**METROPOLITAN GOVERNMENT OF NASHVILLE AND DAVIDSON COUNTY**

**STAFF RECOMMENDATION**  
**2208 18<sup>th</sup> Avenue South**  
**November 14, 2012**

**Application:** New construction – addition  
**District:** South Music Row Neighborhood Conservation Zoning Overlay  
**Council District:** 18  
**Map and Parcel Number:** 10416004000  
**Applicant:** LightWave Solar Electric, LLC., c/o Jon Paul Plumlee  
**Project Lead:** Michelle Taylor, michelle.taylor3@nashville.gov

<p><b>Description of Project:</b> Applicant proposes to install eighteen (18) photovoltaic solar panels on the south facing roof of a hipped roof, two-story, contributing house.</p> <p><b>Recommendation Summary:</b> Staff recommends approval of the south facing roof mounted solar panels because the panels will be flush mounted on the secondary façade therefore minimally visible and their design will not impact the historic character of the building. Staff finds that the project meets sections II.B.I and II.B.2 of the <i>South Music Row Neighborhood Conservation Zoning Overlay Design Guidelines</i>.</p>	<p><b>Attachments</b> <b>A:</b> Photographs <b>B:</b> Site Plan <b>C:</b> Elevations</p>
---	--

South facing facade, solar panels proposed in this location

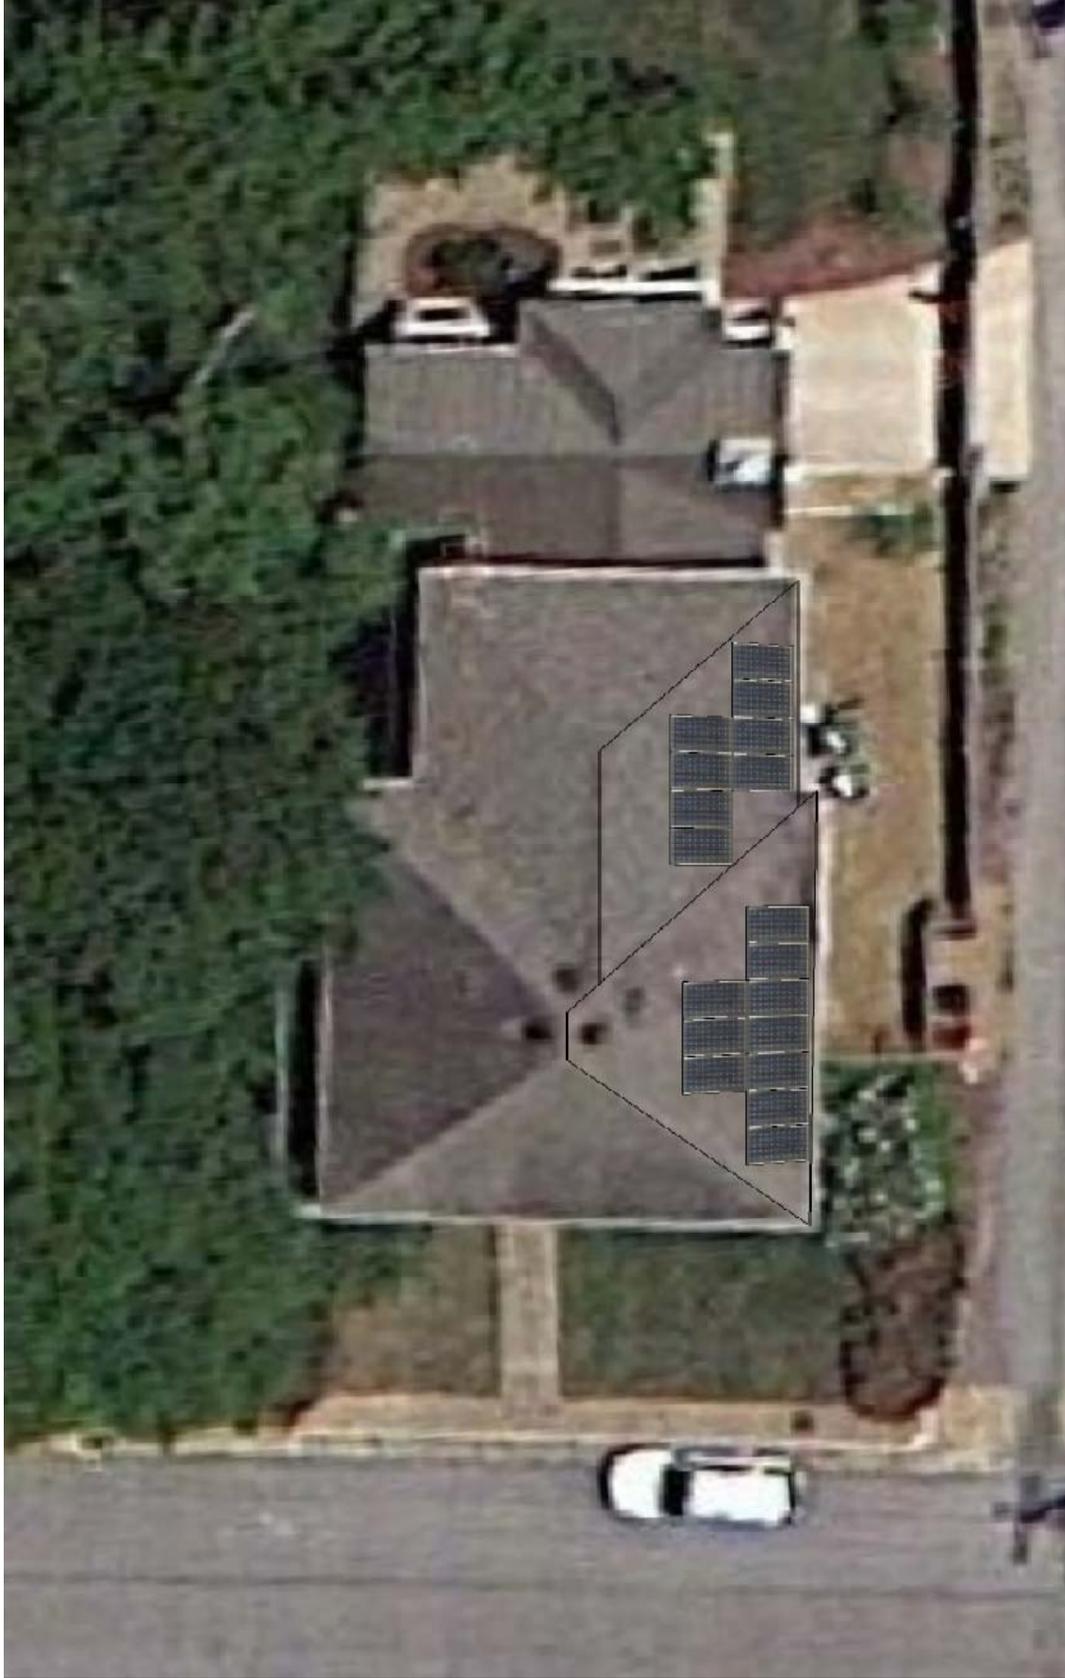
The application is to install a roof mounted solar photovoltaic system on the south facing side roof, which is considered a side addition.

Location: The major impact of solar panels on historic buildings is not necessarily in their installation or materials but in their visual impact; however placement of the panels is critical to their effectiveness and they are not always able to be located in ideal

locations. In this case, the panels are located on a secondary façade and will have minimal visual impact, as seen from the public right-of-way, due to the low-sloped hipped roof. The panels will be flush mounted. The meter and AC disconnect switch will be located adjacent to the existing billing meter. The inverter will be located in the basement. The panels will have minimal impact on the historic home, retaining the original form and existing materials.

Dimension and Design: The design guidelines state that additions should be compatible in scale, materials, and texture. Installation minimally affects the historic home as there are few penetrations and the system can easily be removed without affecting the historic form. Two separate collections of modules (panels) will be installed. One grouping will consist of ten (10) modules and the other with eight (8) modules, all on the south facing side roof. The total collection of panels is proposed to cover approximately fifty percent (50%) of the side slope of the roof and will be black against a red roof. Each panel (64.5" x 38.7") will be attached side-by-side to a flush mounted rail system which as proposed will not protrude off the edge of the roof. Installation has minimum impact on the roof as each panel is attached with clamps to the rail system. In addition, the flush mount design will make the panels minimally visible on the secondary façade.

Staff recommends approval of the south facing roof mounted solar panels because the panels will be flush mounted on the secondary façade therefore minimally visible and they will not impact the historic character of the building. Staff finds that the project meets sections II.B.I and II.B.2 of the *South Music Row Neighborhood Conservation Zoning Overlay Design Guidelines*.
